**RE:** Water Right  
File No. 17,882

**APPROVAL OF APPLICATION  
FOR  
CHANGE IN  
POINT OF DIVERSION  
WATER RIGHT  
FILE NO. 17,882**

RE: Change Applications  
Water Right, File Nos. 17882

## GMD3 Change Review

17882

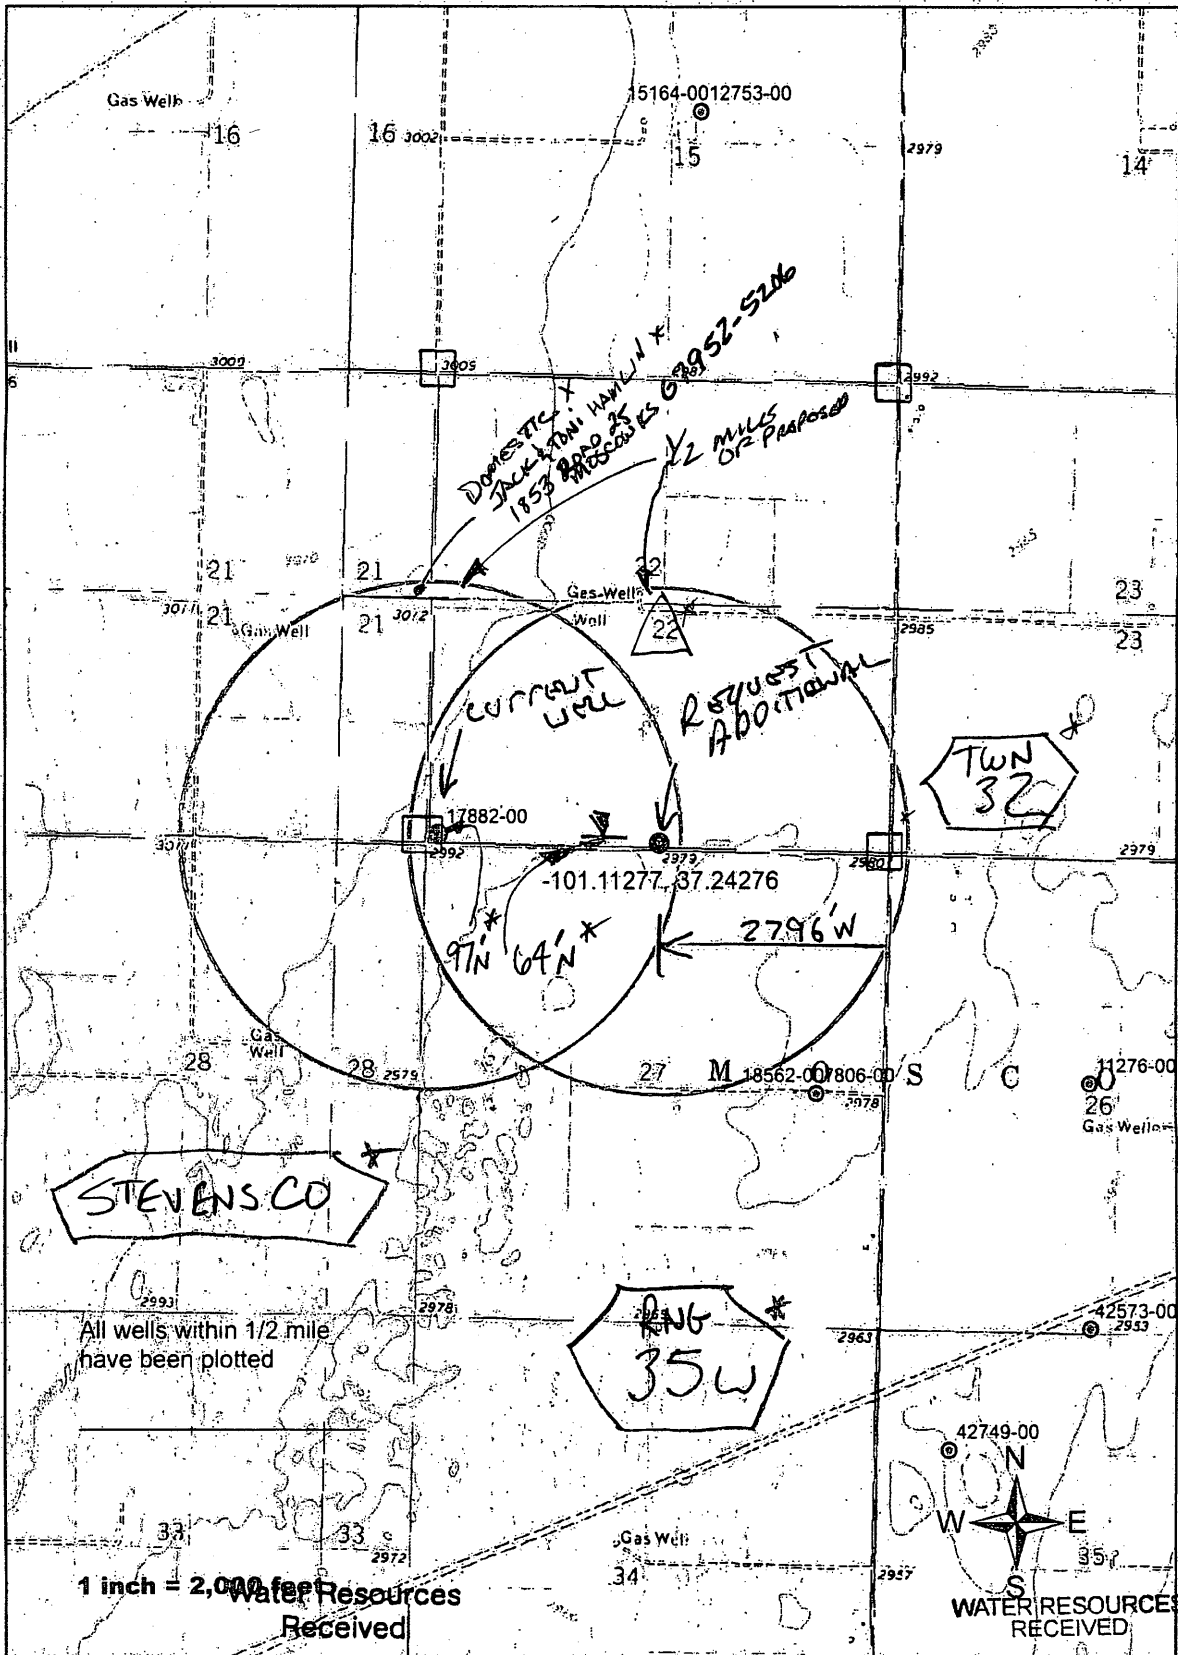
All wells within 1/2 mile have been plotted

Application to Change the Authorized Point of Diversion File No. 17882

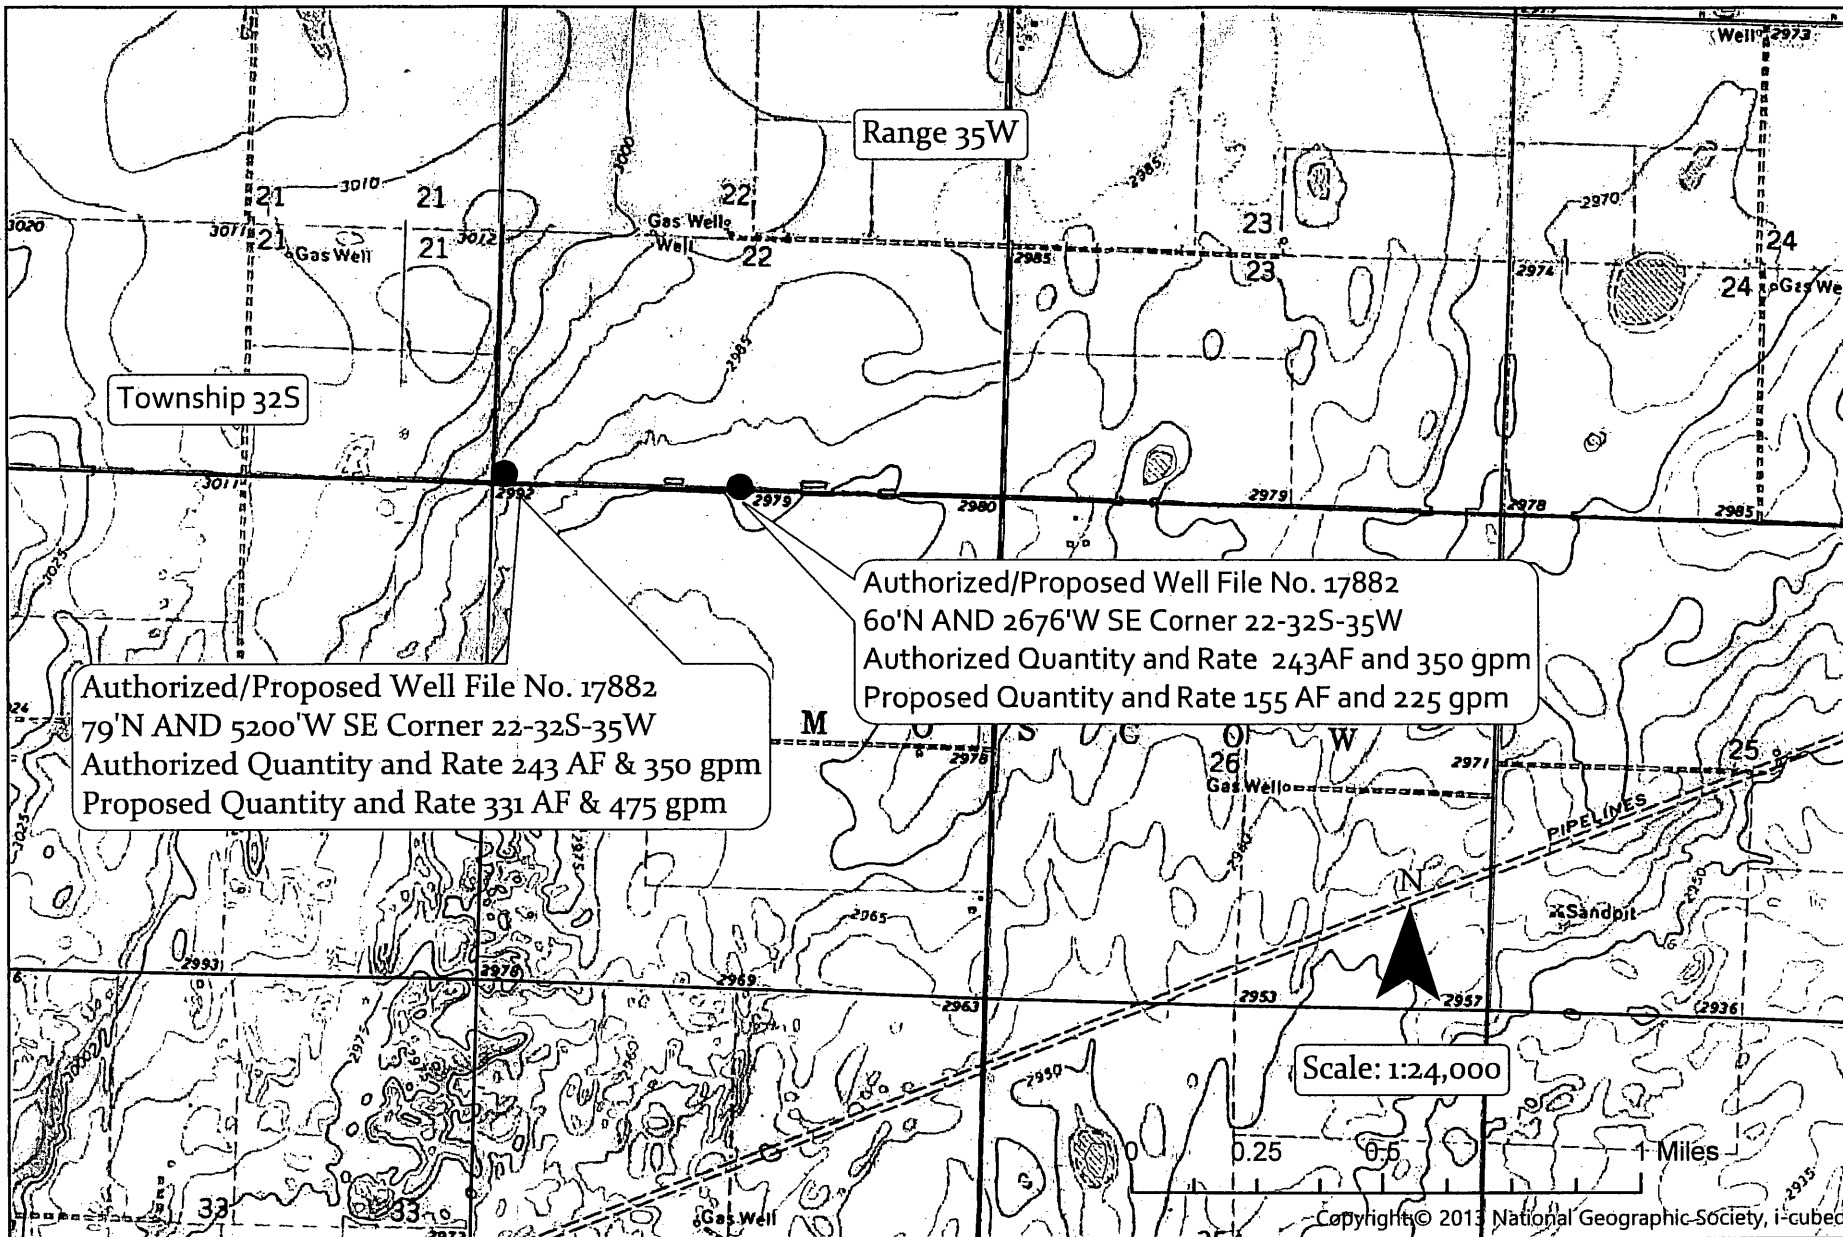
The map from the 2018 approved pd change shows a domestic well (Jack Hamlin) within one-half mile of the west well, however the map from the current pd change does not show it within one-half mile. Do you think we need to notify that domestic well owner?

Also, there are gps feet distances shown for the recently drilled east well but I do not see any gps feet distances in our scanned documents or in WRIS. Have we/do we need to do a compliance investigation on the east well (WRIS ID 4) before we proceed with the change application?

Change in Rate & Quantities  
 File No(s).17882  
 T32 R35W Stevens Co.

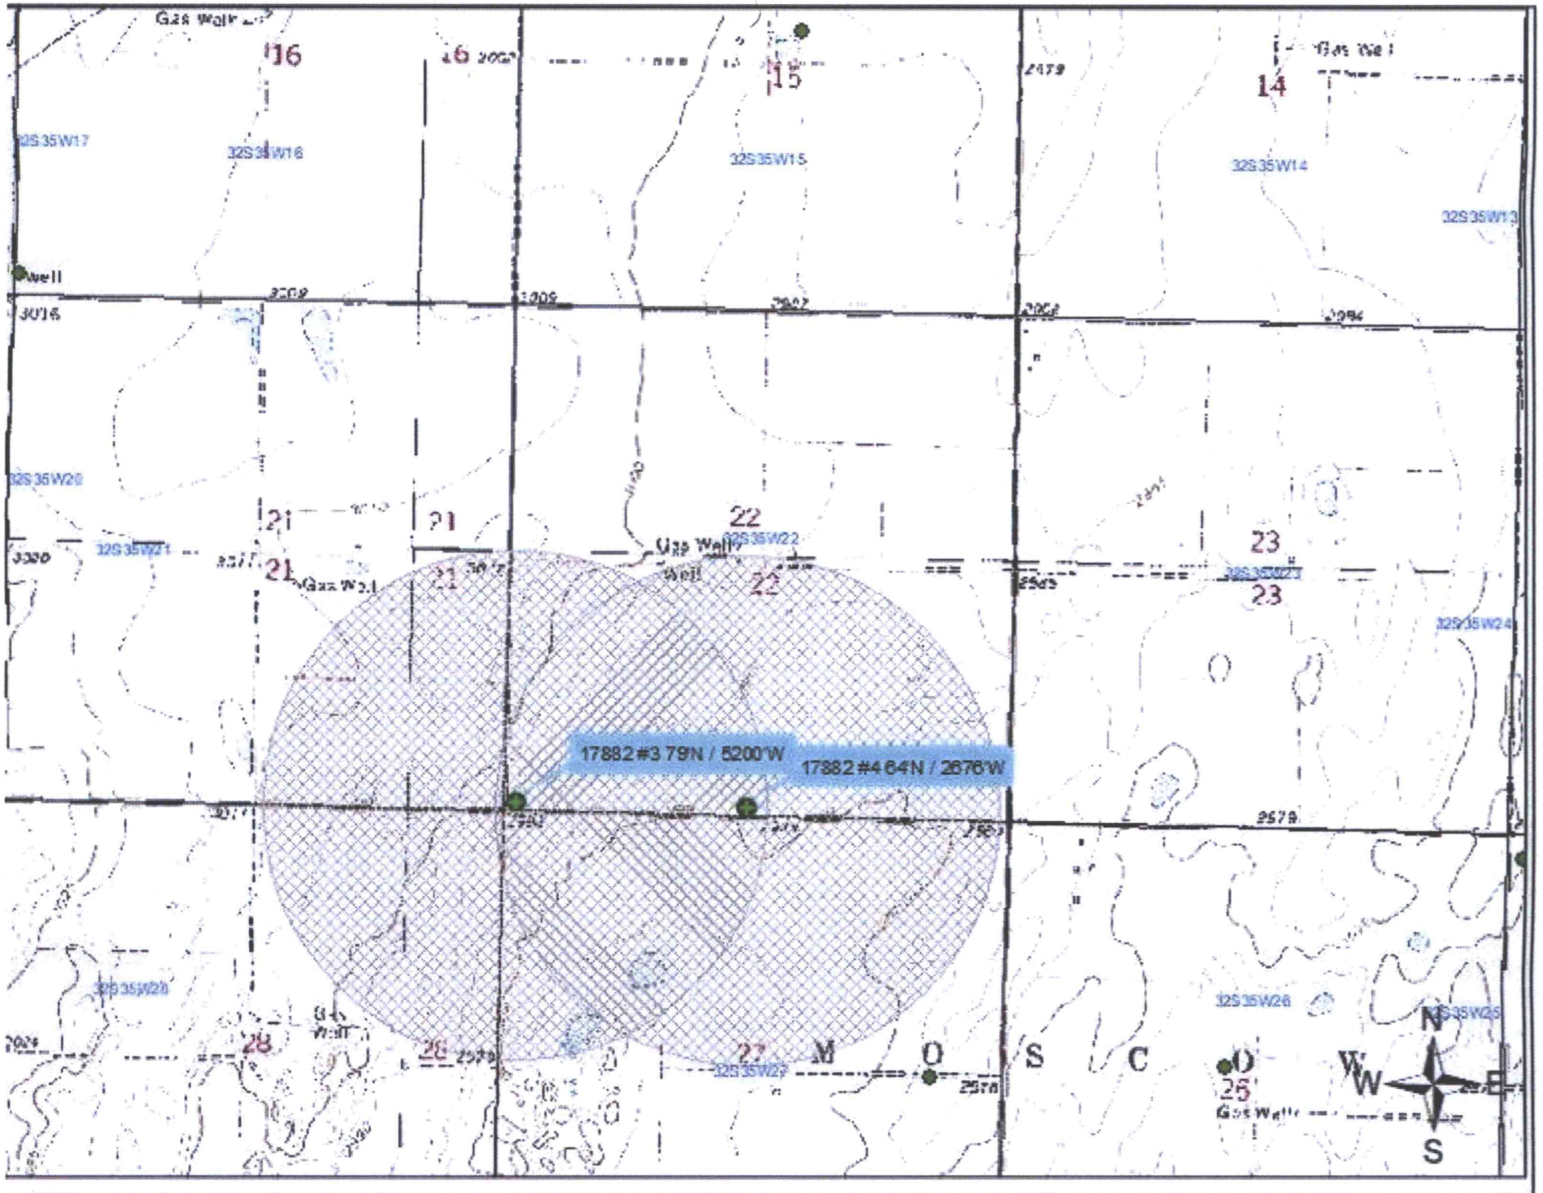
**Application is to reallocate authority between the two wells that are under the same water right.**

**Currently: ID3= 243AF @ 350gpm                      ID4= 243AF @ 350gpm**

**Proposed: ID3= 331AF @ 475gpm                      ID4= 155AF @ 225gpm**

**Change:                      +88AF    +125gpm                      -88AF    -125gpm**

Is a waiver needed: Distance between wells is less than half mile. Spacing to neighboring wells appears to meet current rules.

west original well. Since there is no real history for the east well and this is still a reduction from the original west well, effects would still be reduced for neighboring wells in the area of the west well. Since it meets all current area rules, staff therefore recommends approval of the reallocation.
